ADDENDUM NO. 1

RE: Item #11, October 15, 2025 Letting - NH 0044(249)44, PCN 09VN, Pennington County - Modify Signals

PLANS: Please destroy sheets L2, L4, L5, L10 & L71-L73 and replace with the enclosed sheets, dated

STATE OF	PROJECT	SHEET	TOTAL SHEETS
SOUTH			SHEETS
	NH 0044(249)44		l
DAKOTA	1411 0044(243)44	L10A	L75

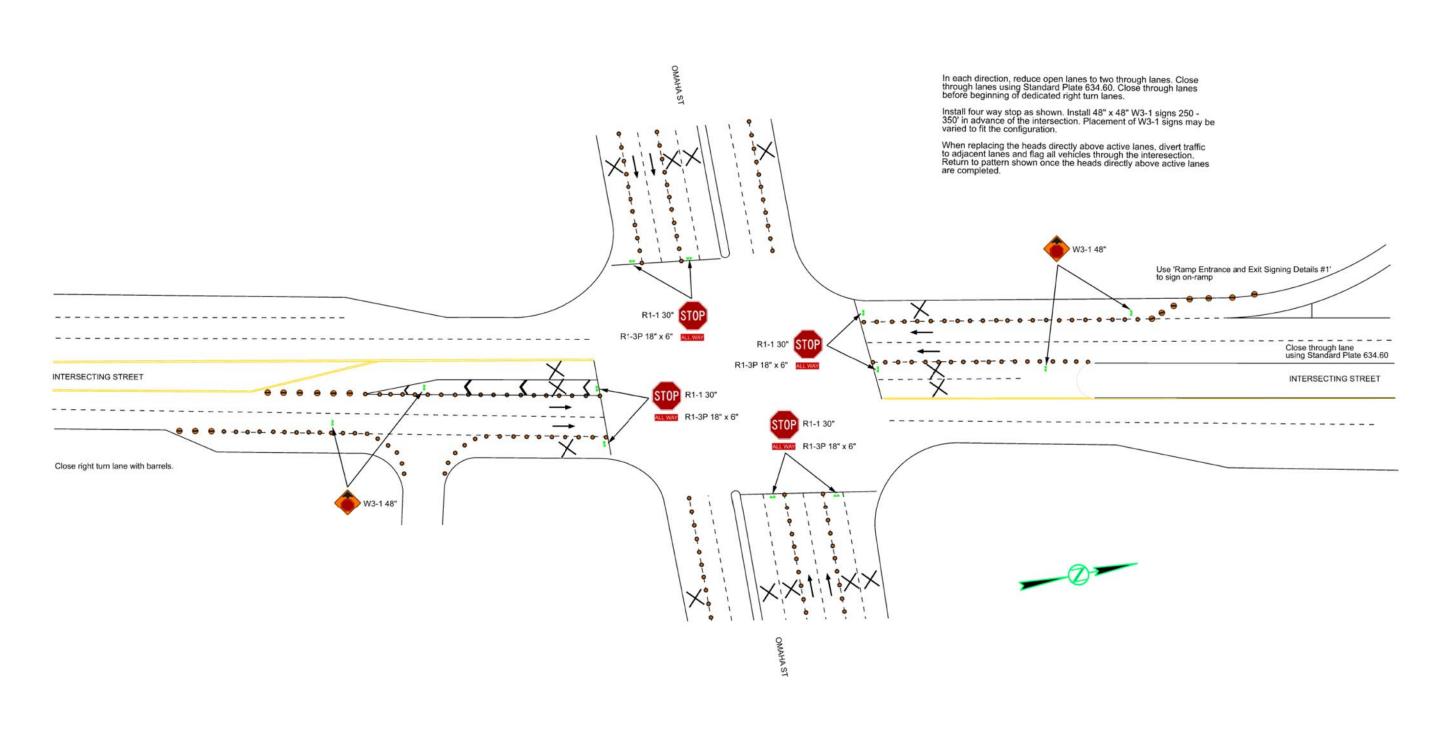
Sheet L10A: TYPICAL LAYOUT FOR 4 WAY STOP CONTROLLED INTERSECTIONS –

INTERSECTING STREET sheet was added.

STATE OF	PROJECT	SHEET	TOTAL
ı	SOUTH			SHEETS
	DAKOTA	NH 0044(249)44	L10B	L75

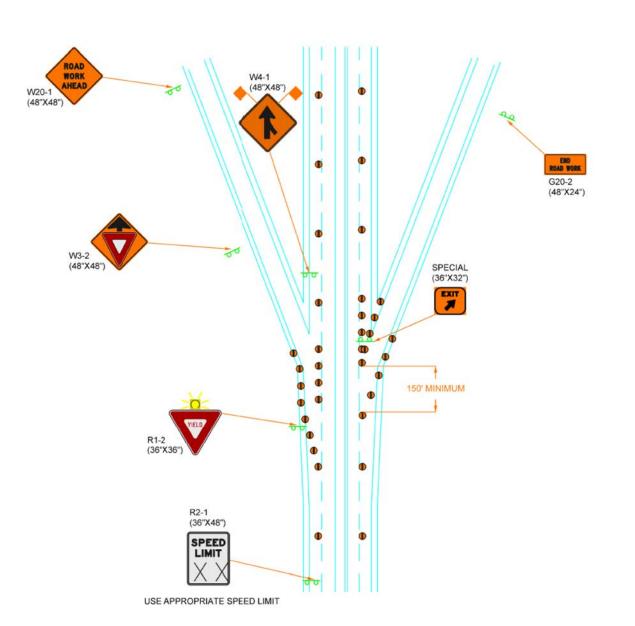
Sheet L10B: RAMP ENTRANCE AND EXIT SIGNING DETAILS #1 sheet was added.
